ASSEMBLY & PRE-DELIVERY
BULLETIN NO. 03-27
DATE: 11/20/2002

SUBJECT: GSX1300RK3 ASSEMBLY & PRE-DELIVERY PROCEDURES

REFERENCE: GSX1300RX ASSEMBLY GUIDE (99505-01269-03E) &
SERVICE BULLETIN - GENERAL #38 - INITIAL BATTERY SERVICE

DIFFERENCE BETWEEN GSX1300RX AND GSX1300RK3

UNDER COWL PLATE

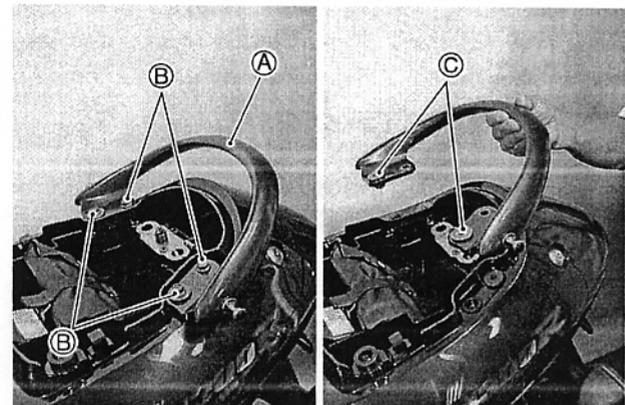
Install the under cowl plate.

Make sure that the stepped allen screws © (right and left) are tightened securely.

SEAT TAIL COVER

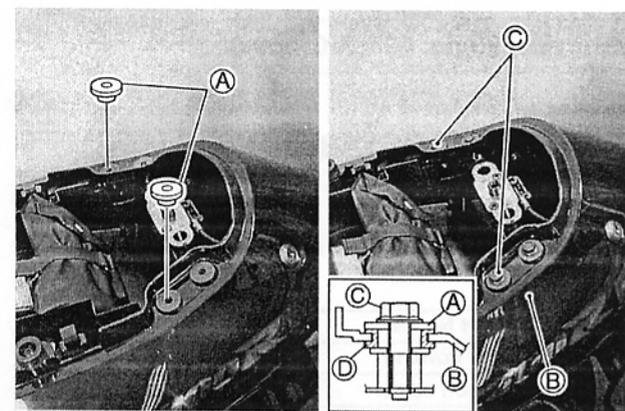
2. Remove the pillion handle assembly with removing four bolts.

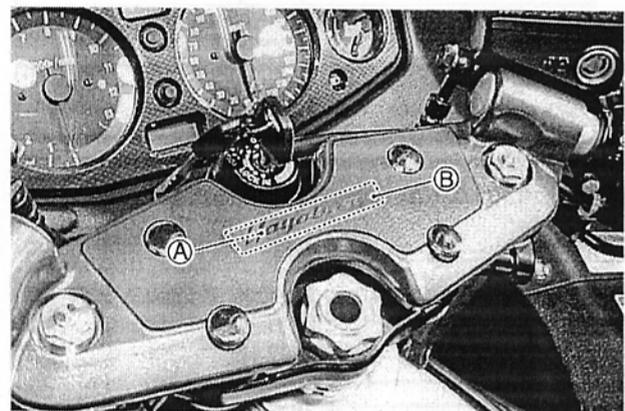
3. Attach the spacer as shown in the photograph. Retighten the bolts as shown in the photograph.

BATTERY [Page: 10]

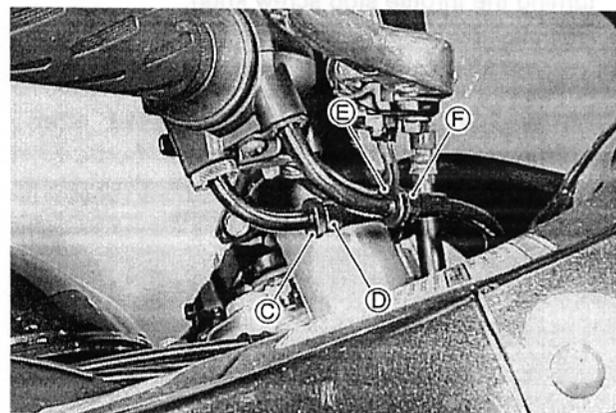
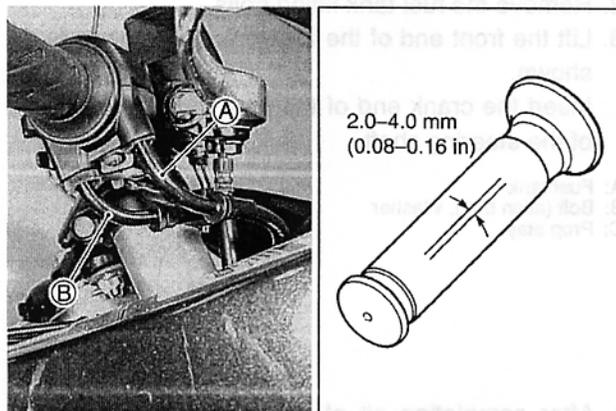
Charge the battery with a battery charger.

For charging the battery, make sure to use the charger specially designed for MF battery. Otherwise, the battery may be overcharged resulting in shortened service life.

Do not remove the cap during charging.

Position the battery with the cap facing upward during charging.

IDLE SPEED ADJUSTMENT

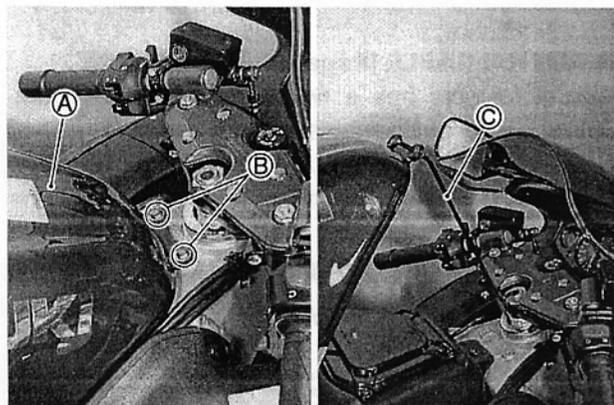
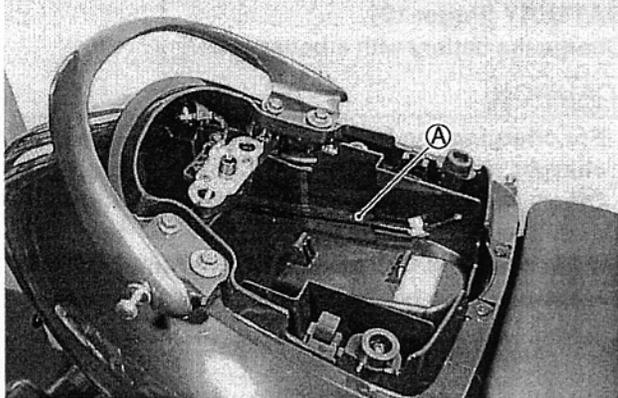
The prop stay is located under the rear seat.

Remove the rear seat using the key.

Remove the prop stay.

1. Remove the front seat.

2. Remove the fuel tank fitting bolts.

3. Lift the front end of the fuel tank and prop it up as shown.

Insert the crank end of the prop stay into the hole of the steering shaft.

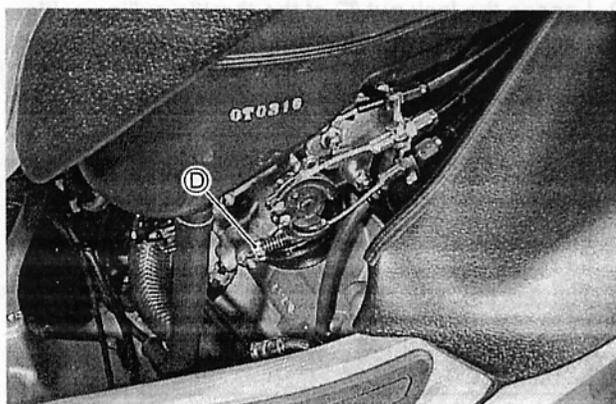
4. After completing all of the servicing procedures and the test ride, adjust the engine idle speed by turning the throttle stop screw knob.

The engine idle should be adjusted after engine warm up.

Engine idle speed: 1 050–1 250 r/min
